Office of General Services

ADDENDUM NO. 1 TO PROJECT NO. 47082

CONSTRUCTION AND ELECTRICAL WORK REHABILITATE WATER FILTRATION PLANT ADIRONDACK CORRECTIONAL FACILITY 196 RAY BROOK ROAD RAY BROOK, NY

March 9, 2026

DRAWING NUMBER: C-001

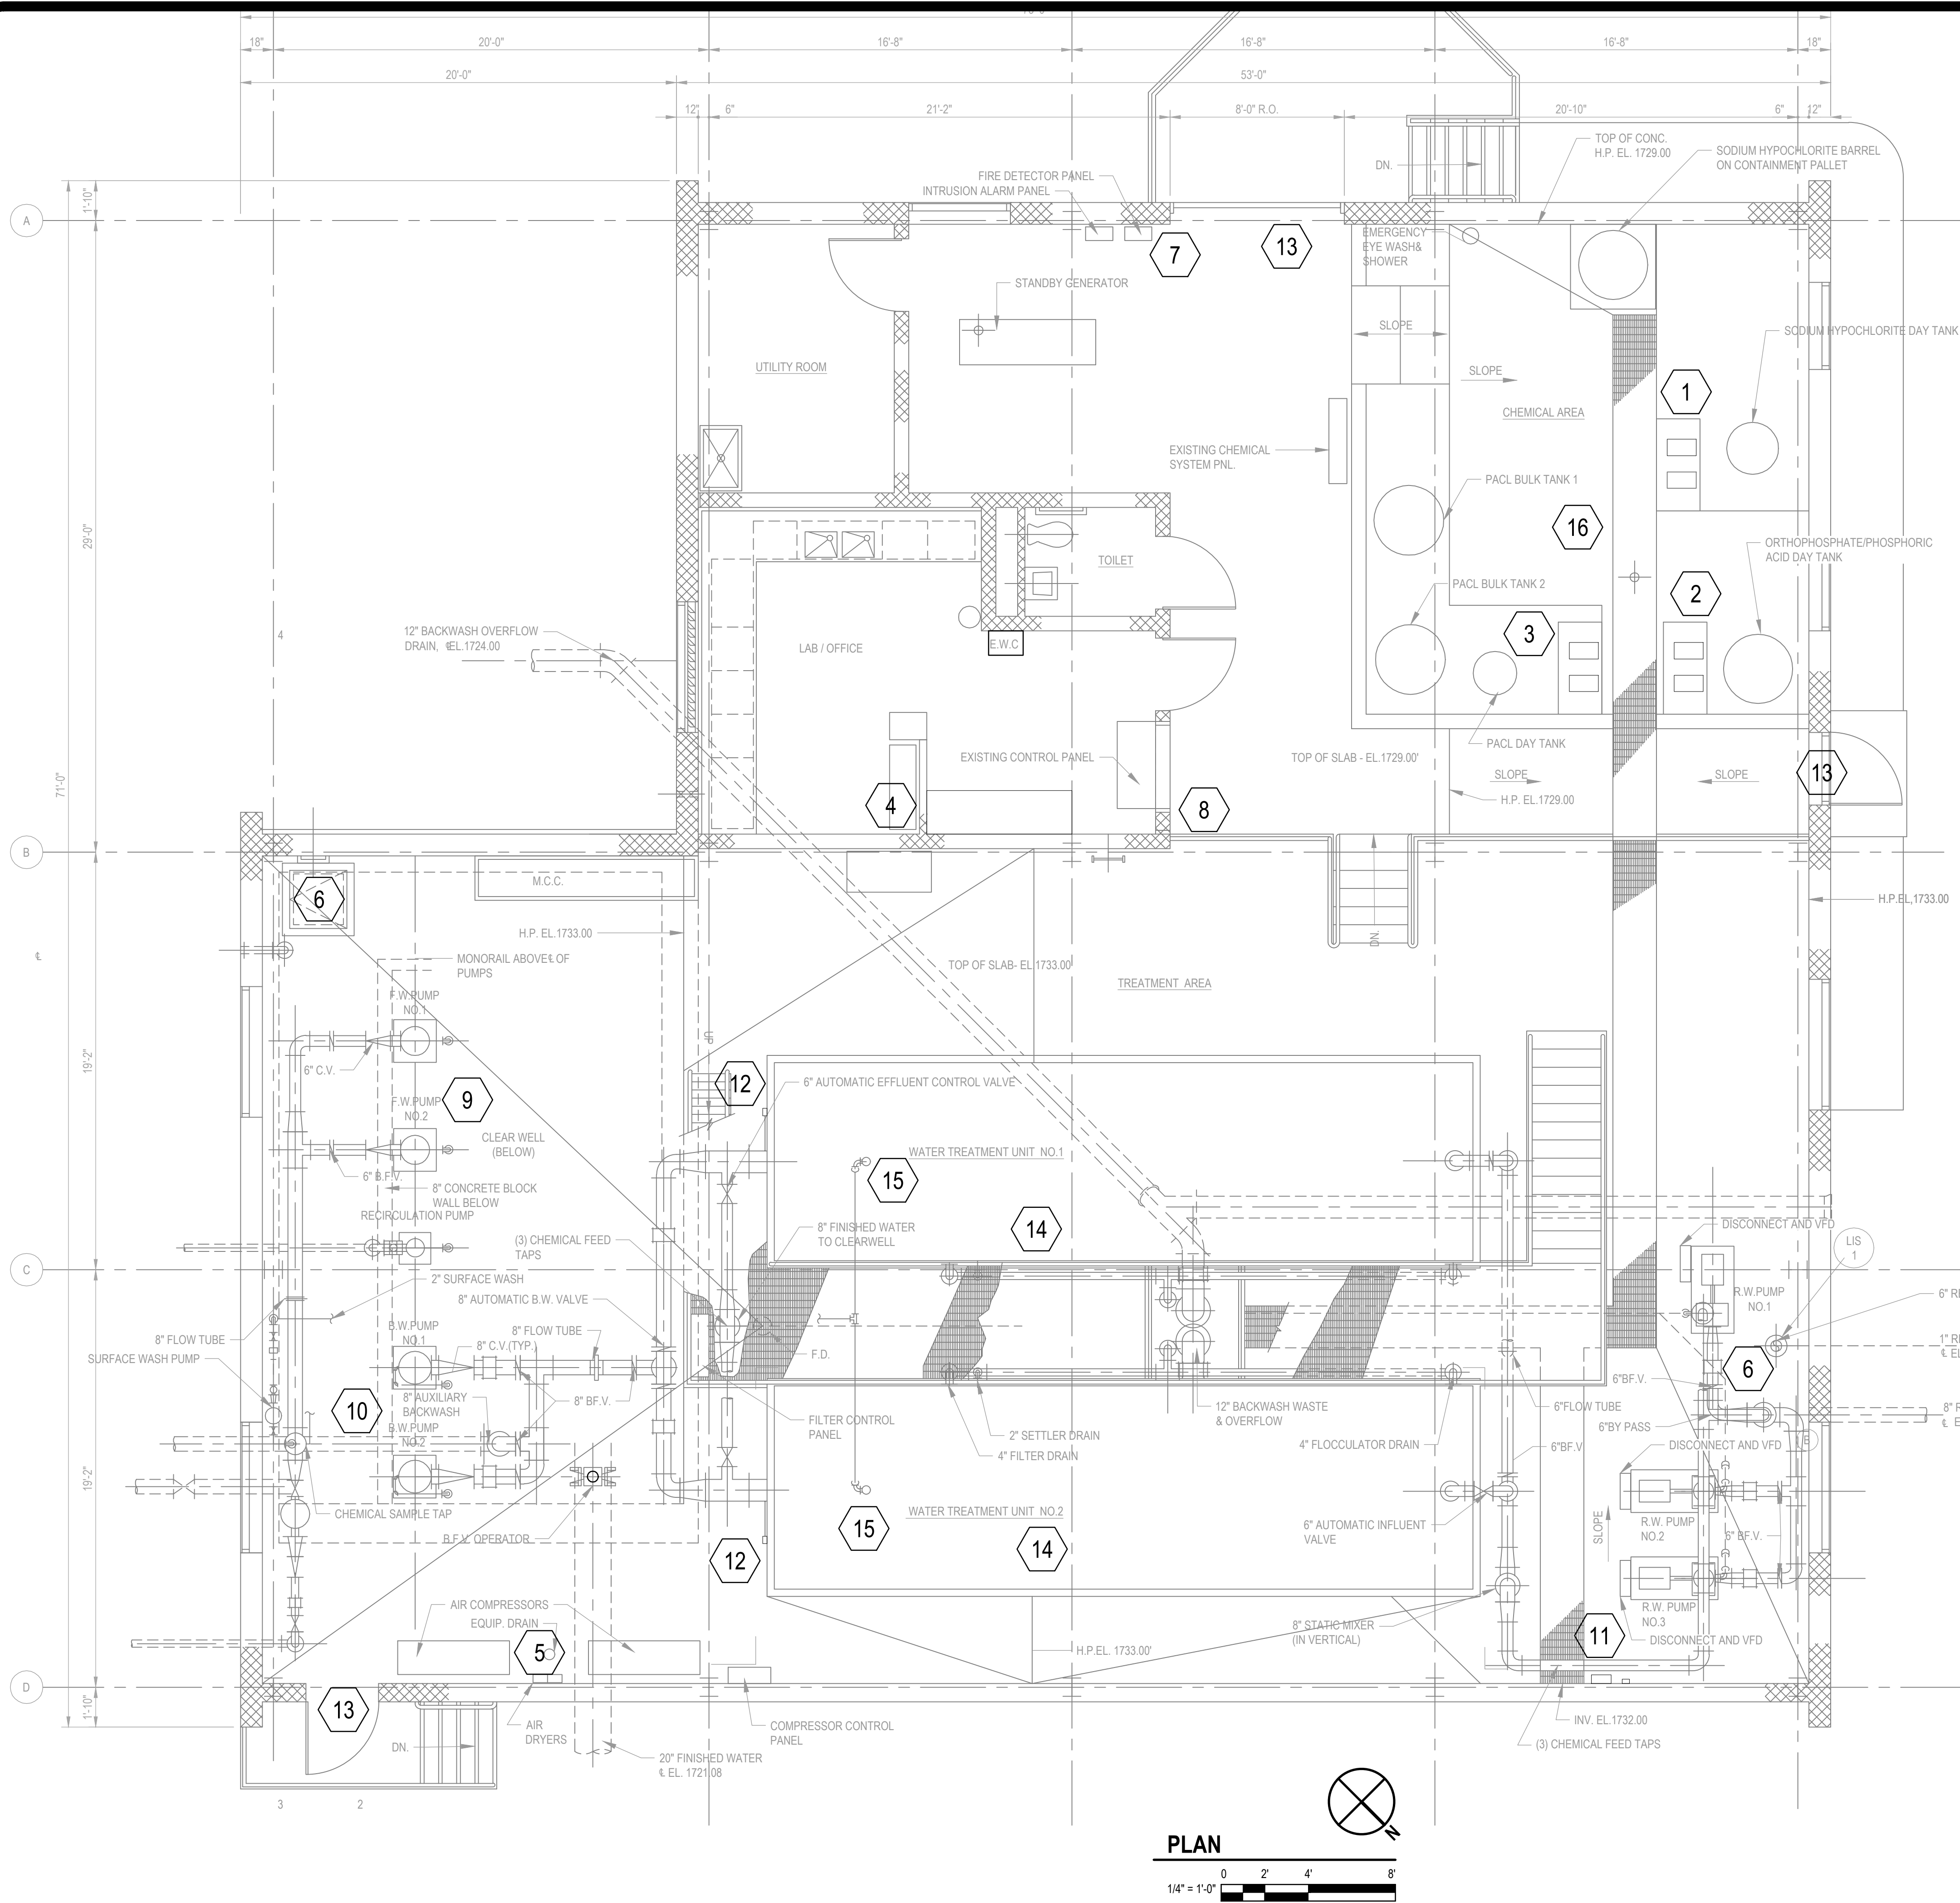
4. Revised Drawing:
 - a. Drawing No. C-001, noted Addendum 1 dated 3/6/2026, accompanies this Addendum and supersedes the same numbered previously issued drawing.

02	3/6/2026	Addendum 1
01	11/7/2025	BID DOCUMENT
MARK	DATE	DESCRIPTION
PROJECT NUMBER:	47082 - E	
DESIGNED BY:	LMI	
DRAWN BY:	LMI	
FIELD CHECK:	JER	
APPROVED:	JER	
SHEET TITLE:	FACILITY PLAN	
DRAWING NUMBER:	E-006	
SHEET	20	of 27

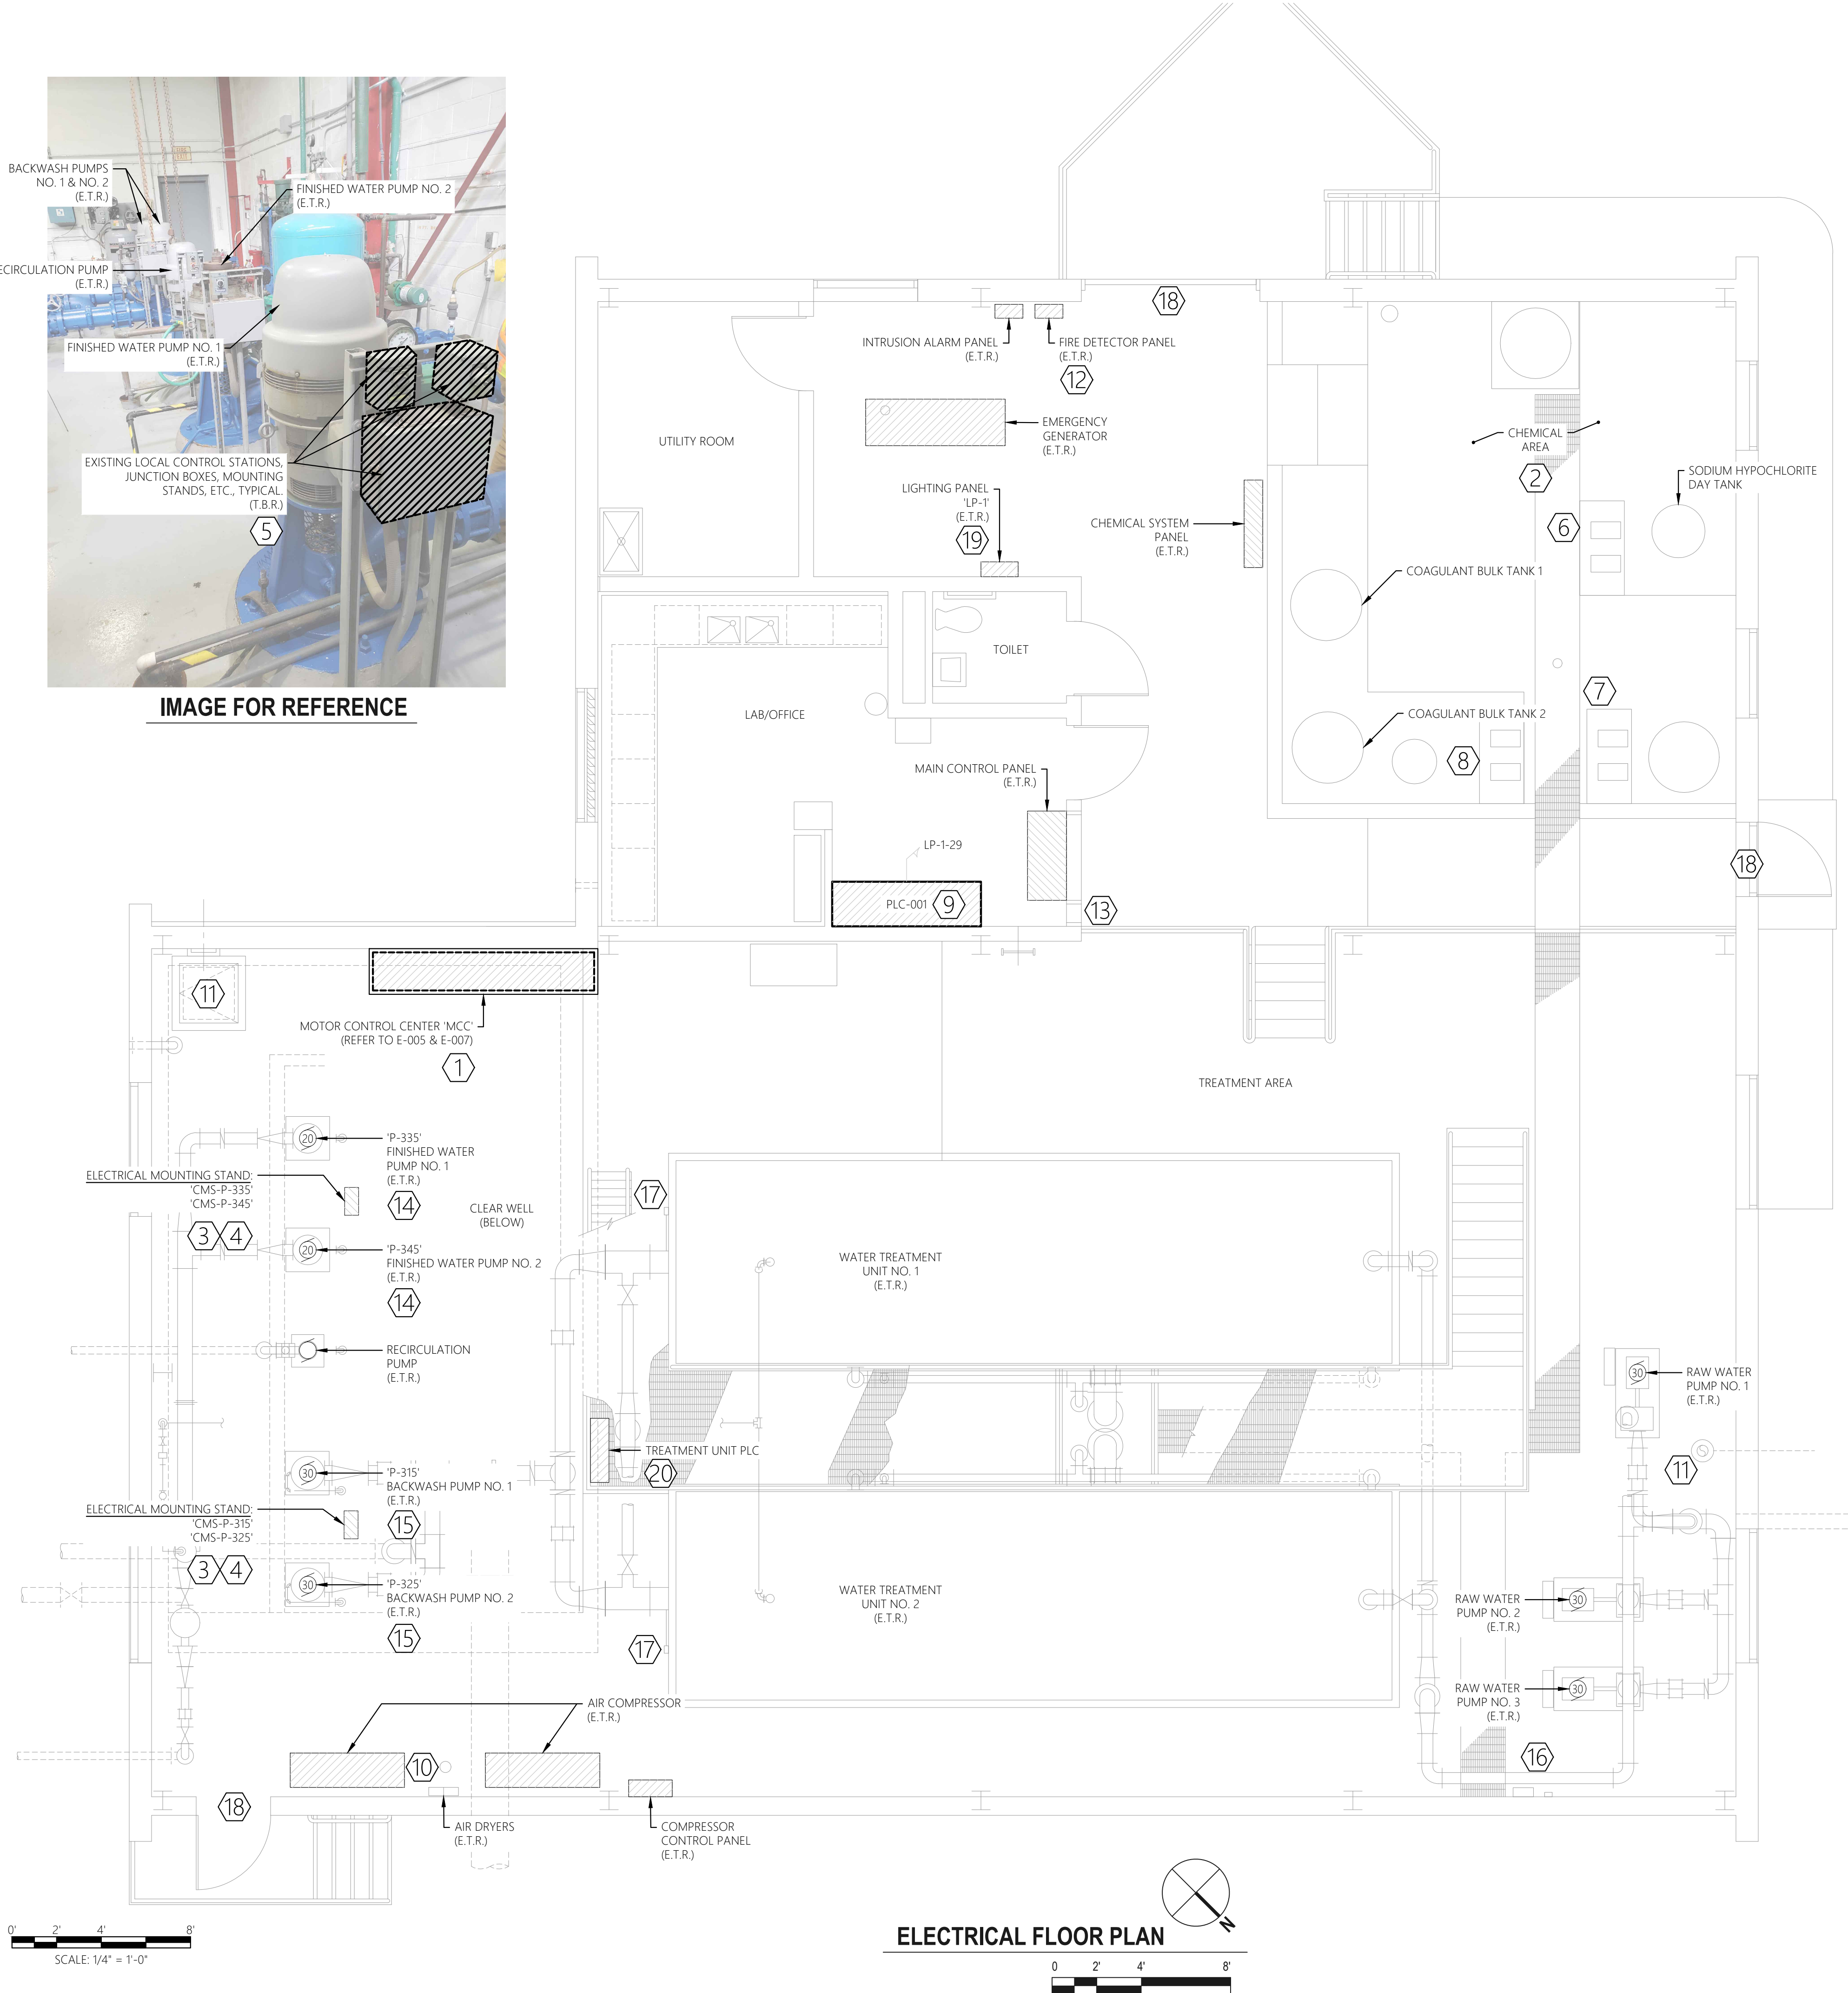
5. Revised Drawing:
 - a. Drawing No. E-006, noted Addendum 1 dated 3/6/2026, accompanies this Addendum and supersedes the same numbered previously issued drawing.
